From: Thomas Barron <barron@imageg.com>
To: aaron.O.Allen@usace.army.mil
Date: Mon, Aug 24, 2009 4:40 PM
Subject: NEWHALL RANCH - RMDP comments

US ARMY CORPS OF ENGINEERS
Re: Application No.: 2003-01264-AOA
NEWHALL RANCH - RMDP testimony

123. Letter from Thomas Barron, dated August 24, 2009

TWO WAYS TO CROSS THE HIGHWAY

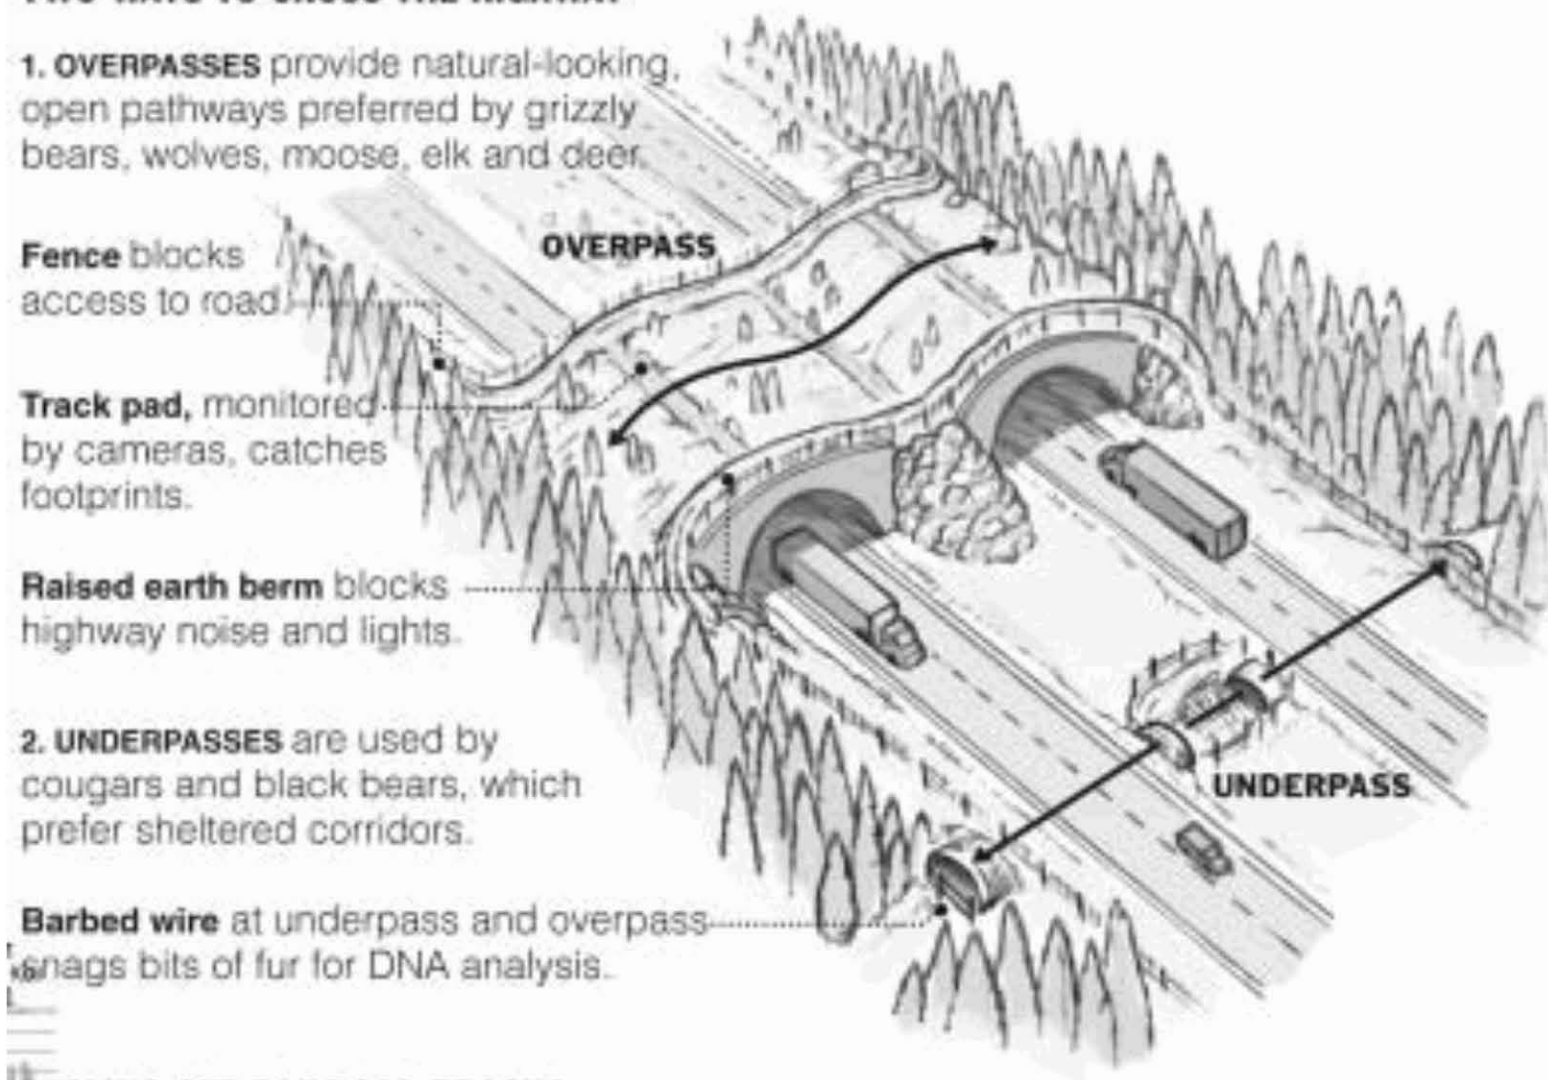
The alternative of building an animal overpass (such as in Banff - see attached picture and reference) isn't considered in the plan. This, albeit expensive option, would open an entire new set of considerations for an effective Corridor and Linkage. These overpass solutions would be recommended for the Salt Creek area, where the highway meets the hillside on the north and there is now no natural passage. (This area has already been the site of major road kills, including mature bears, and is west of the new traffic to enter highway 126 from the cross valley connections and Portrero Canyon.)

The comment states that the alternative of building a wildlife overpass is not considered in the Draft EIS/EIR and provides an example that was constructed in the Canadian city of Banff. The commentor recommends such an overpass for the Salt Creek area where SR-126 meets the hillside in the north.

As described in **Response 5**, the Draft EIS/EIR provided information and analysis regarding wildlife movement and connectivity in the Project area. This included a detailed description of the existing man-made wildlife crossings that occur in the Project area related to SR-126. **Figure 4.5-32** of the Draft EIS/EIR shows six of the largest existing crossings that can be accessed by wildlife coming directly from adjacent uplands or by moving along the Santa Clara River. These six crossings are associated with current agricultural operations and are bridges or culverts large enough for vehicle passage. The large culverts in Ventura County are about 4.4 meters (14 feet, 7 inches) in height, 7.5 meters (25 feet) in width, and 51.8 meters (170 feet) in length. The Draft EIS/EIR identified these culverts to have an openness factor of 0.65, which well exceeds the openness factor of 0.25 found by Donaldson (2005) to be adequate for white-tailed deer. Based on this and other analysis in the document, the Draft EIS/EIR determined the existing passages would be expected to provide adequate passage for high-mobility ground-dwelling species such as mule deer, mountain lion, and black bear. The easternmost of the Ventura County crossings serve wildlife passing through the Project area via the Salt Creek corridors discussed above as well as Tapo Canyon in Ventura County. There are also existing crossings at the San Martinez Grande Canyon, Chiquito Canyon, and at the Castaic Creek confluence with the Santa Clara River. These crossings are short and open and include soft bottom underpasses at the San Martinez Grande Canyon and Castaic Creek crossings and a large parallel set of box culverts at the Chiquito Creek crossing (**Figure 4.5-32**). These crossings would not significantly constrain current wildlife movement in the area.

Although the construction of a wildlife overpass would provide greater passage opportunities for some wildlife and potentially reduce roadkill, analysis in the Draft EIS/EIR determined that at the existing large agricultural undercrossings in Ventura County, wildlife, including bear and mountain lion, would be able to effectively move north and south via the Salt Creek area and High Country SMA. Because the impact would not be significant, a new wildlife overpass is not necessary to provide for wildlife crossings in this area. For further information related to wildlife corridors and wildlife movement, please refer to **Topical Response 12: Wildlife Habitat Connectivity, Corridors, and Crossings**.
